MXD COMMERCIAL

DESIGN REVIEW COMMITTEE 19 APRIL 2022

PICKARD CHILTON

OCTOBER 2021 MASSING

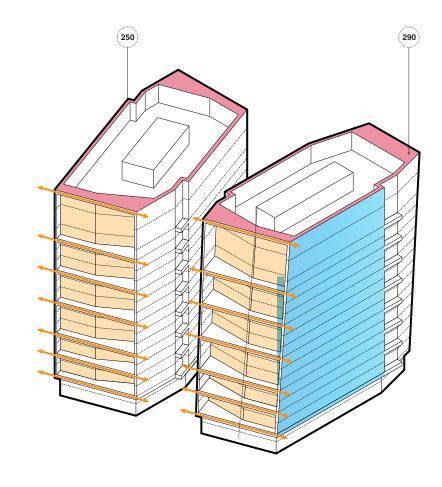
- 2. Articulation on ends stepped back at mid-points in facade.
- 3. Continuous faces over full height increase 'monumental' feel.
- 4. Building podium reads strongly and is prominent on groundplane.
- 5. Bridge instances flexible in location, scale, and quantity.

- 1. Flat roofline reads strongly from groundplane.
- 2. Articulation on ends adds to 'monumental' feel.
- Unbroken balconies increase building horizontality.
- 4. Balcony location contributes to long facades from Binney.
 - 5. Bridge instances flexible in location, scale, and quantity.

APRIL 2022 MASSING

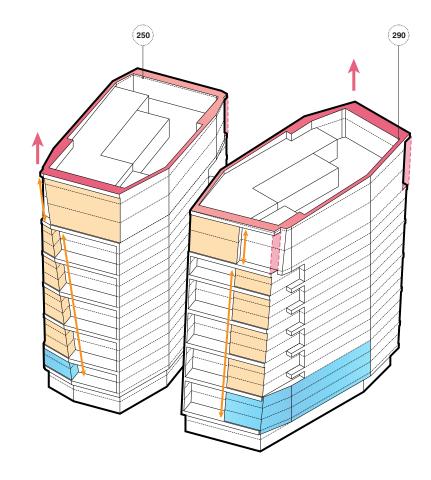
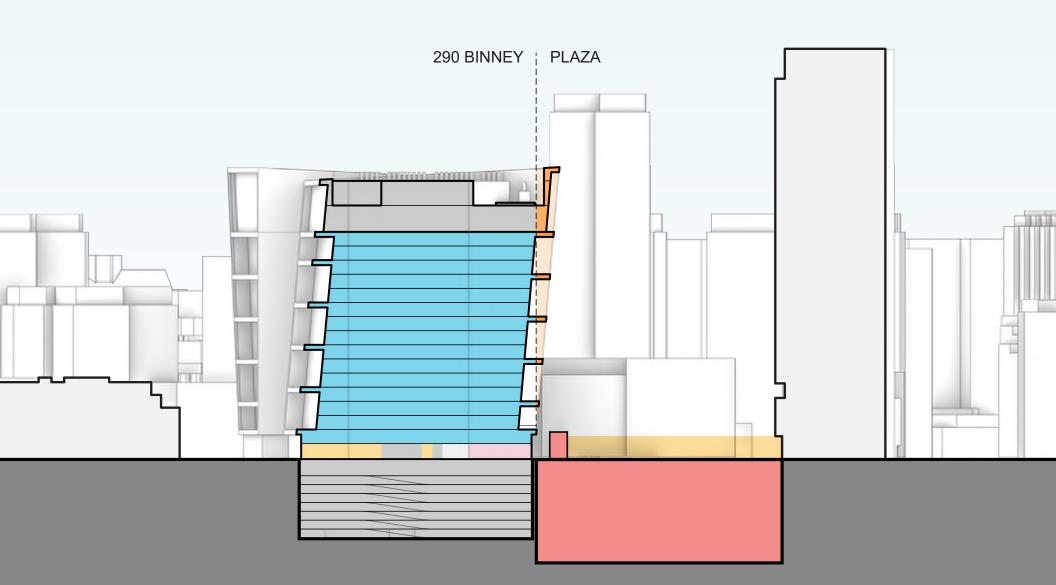
- 2. Added articulation on Binney and Central Plaza frontages.
- 3. Massing changes reduce horizontal read of building.
- 4. Balcony locations adjusted to minimize unbroken facade lengths.

- 1. Remove wing wall conditions at tower top for added articulation.
- Shifted end bay articulation to mark the tower top.
- Consistent end bay articulation through typical floors to reduce horizontal read of building.
- 4. Revisions to respond to streetwall height of neighboring buildings

BRIDGE LOCATION - 19 APR 22

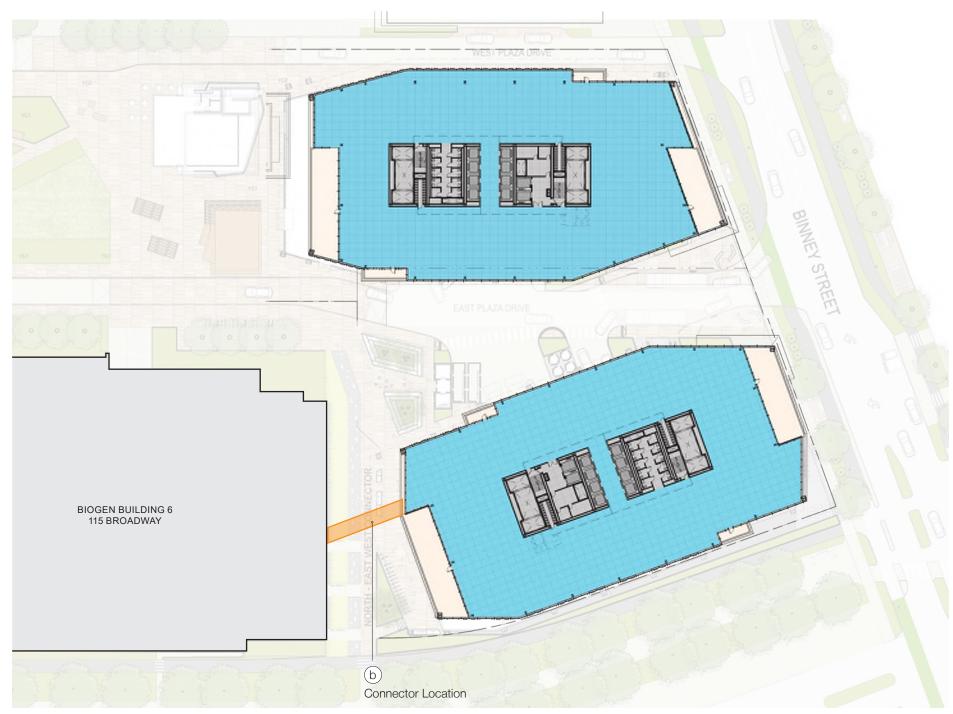
- Study opportunities to meet 'Base / Middle / Top' strategy as noted by City guidelines.
- Massing moves should remain related to site context.
- If the bridges are proposed, it would be good to better understand the amount and scope.
- Building tops are important, study how to differentiate the buildings in this zone.
- Buildings may be too similar, study ways to create "cousins not twins".

- a. Higher potential building connectors provide architectural interest and allow for large floor plate for dedicated uses.
- Lower potential building connectors create visual intrigue and add to rich pedestrian experience.
 - All potential connectors are at least 2 stories above grade.
